Our Ref: NWH:TIA004/4003

**SSD 9978934: Submission regarding critical remaining safety issues as a result of the redevelopment of Cockle Bay Park**

Project/File: 300303367

**Reference: Cockle Bay Park Redevelopment SSDA - Transport Review**

Figure 4: Proposed CBP Loading Dock Access Arrangement

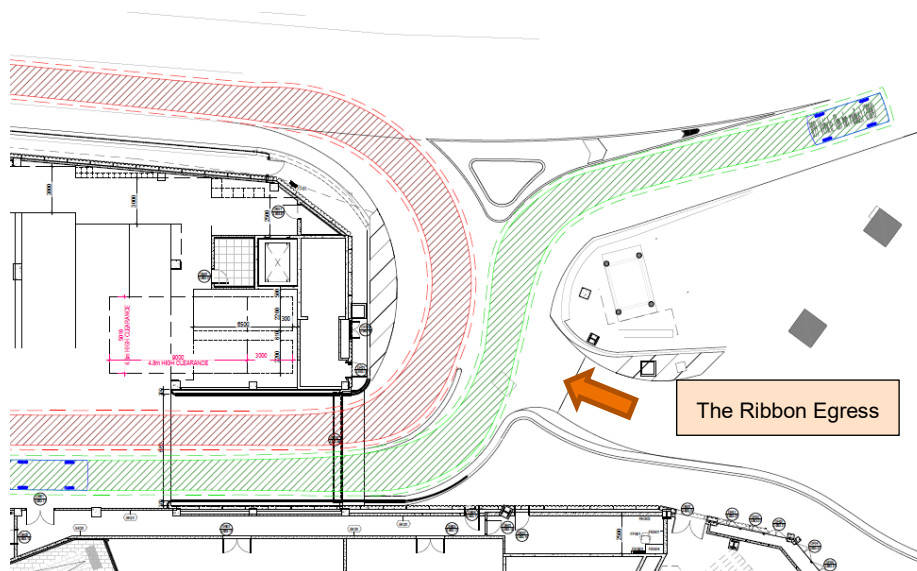
Vehicles departing The Ribbon are required to use the new left-in/ left-out intersection on Harbour Street, with The Ribbon egress road forming a minor leg to a new T-intersection created in between the two sites thus requiring The Ribbon traffic to give priority to vehicles entering and exiting the proposed Cockle Bay Park loading dock. The proposed CBP loading dock access arrangement is illustrated in Figure 4.

- The proposed arrangement will require vehicles departing The Ribbon to stop and give way to both vehicles entering and exiting the CBP loading dock prior to proceeding towards Harbour Street, and again stop and give way to vehicles at Harbour Street. The existing/ approved The Ribbon design only required exiting vehicles to stop and give way to vehicles at Wheat Road (i.e. one movement and lower traffic volumes, compared to three movements proposed).
- The stop line for The Ribbon egress has been set back some seven to eight metres into the site compared to the approved arrangement, to cater for the new CBP loading dock access.
- The stop line is also set back some three metres from where The Ribbon egress intersects the CBP loading dock access. This distance is inconsistent with Australian and NSW road design guidance,

- Three additional column structures are proposed within the area between the CBP entry slip lane and The Ribbon egress, as well as a concrete barrier along the entry slip lane.

- Computer-generated video prepared by Urbis shows that the additional column structure and concrete barrier gives vehicles departing The Ribbon about one second to view vehicles merging into the CBP slip lane.

- These additional CBP structures therefore significantly reduce the available sight lines towards vehicles approaching the CBP loading dock along Harbour Street, which is further compounded by:

- The Ribbon egress being some 500mm lower than the Harbour Street carriageway
  - existing pedestrian bridge column and footing structure
  - approved landscaping for The Ribbon located adjacent to the relocated stop line which was designed for the existing egress arrangement

- drivers being required to turn their head significantly beyond 90-degrees to view vehicles merging into the CBP slip lane.
- The combination of the above points will result in a high likelihood that a vehicle departing The Ribbon may not observe trailing/ follow-up vehicles entering or exiting the CBP loading dock (i.e. additional vehicles following the first vehicle). This increases the chances of the vehicle departing The Ribbon crashing with any trailing/ follow up vehicles if second or third checks are not completed by the departing vehicle, as illustrated in the Urbis computer-generated video.

- There is a clear requirement to mitigate the present safety issues resulting from the CBP Redevelopment, particularly when considering most of traffic generated by The Ribbon will comprise of drivers (i.e. hotel guests and taxi/ ride share drivers) unfamiliar with the complex egress arrangement. Greaton proposes to change the approved landscaping for The Ribbon to aide in reducing the sight line obstructions. However, the critical changes required are the widening of the CBP loading dock access driveway to accommodate independent two-way traffic flows for all design vehicles and the removal/ redesign of the CBP column structure and concrete barriers to

significantly improve the available sight lines and viewing period for a vehicle departing The Ribbon, which is necessary given the complex arrangement being proposed.

**Figure 5: Stantec Swept Paths for proposed CBP Loading Dock Access Driveway Opening**

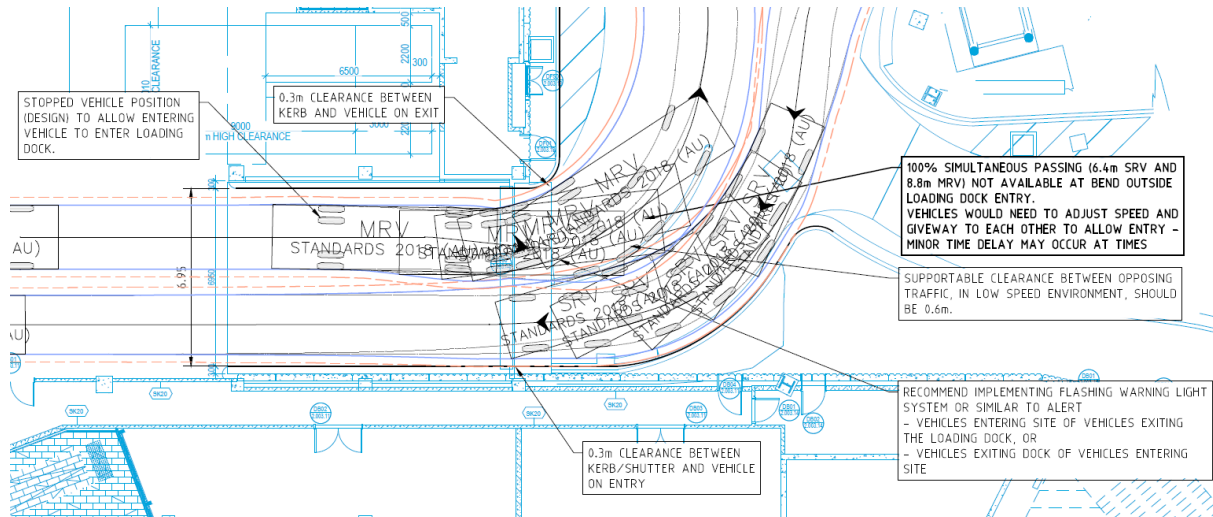
- Further compounding this situation is the inability for an 8.8 metre Medium Rigid Vehicle to independently pass another similar or smaller truck along the CBP loading dock access driveway (as illustrated in Figure 5); scenarios that are probable given there are two Medium Rigid Vehicle and two Small Rigid Vehicle bays proposed in the CBP loading dock, with the dock expected to receive 400 deliveries daily or 30 deliveries per hour (a delivery every two minutes) based on a 14 hour loading dock operating hours<sup>1</sup>. Although dock management protocols (e.g. staggered booking times) are proposed manage the situation, any delays for vehicles navigating past each other to/ from the CBP loading dock will delay vehicles departing The Ribbon and/ or present safety issues given the complexity of the immediate area, therefore having further consequences to the operation of The Ribbon (as well as the CBP loading dock) and potential knock-on effects on Harbour Street traffic flow.

**Figure 6: Stantec Swept Paths for required CBP Loading Dock Access Driveway Opening**

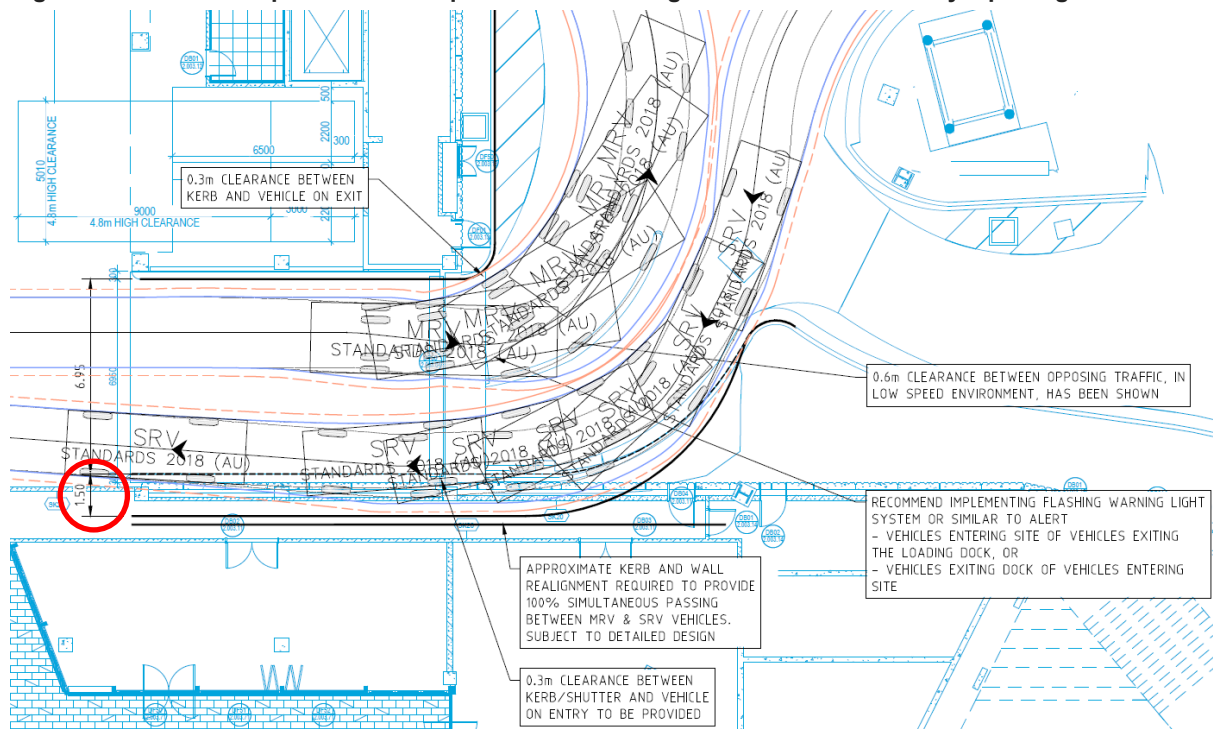
- Swept path analysis completed as part of this transport review suggests that the CBP loading dock access driveway would need to be widened by at least 1.5 metres to accommodate independent two-way traffic flows for all design vehicles, as illustrated and highlighted in the Figure 6 alternative design.

- 4.7 If the proposed loading dock is increased in width by 1.5m, this will allow all vehicle types to simultaneously pass each other with the addition of clearances. Cockle Bay Park and the W Hotel will then both have a viable traffic solution that is sufficient for both services and with a reduced risk of injury.
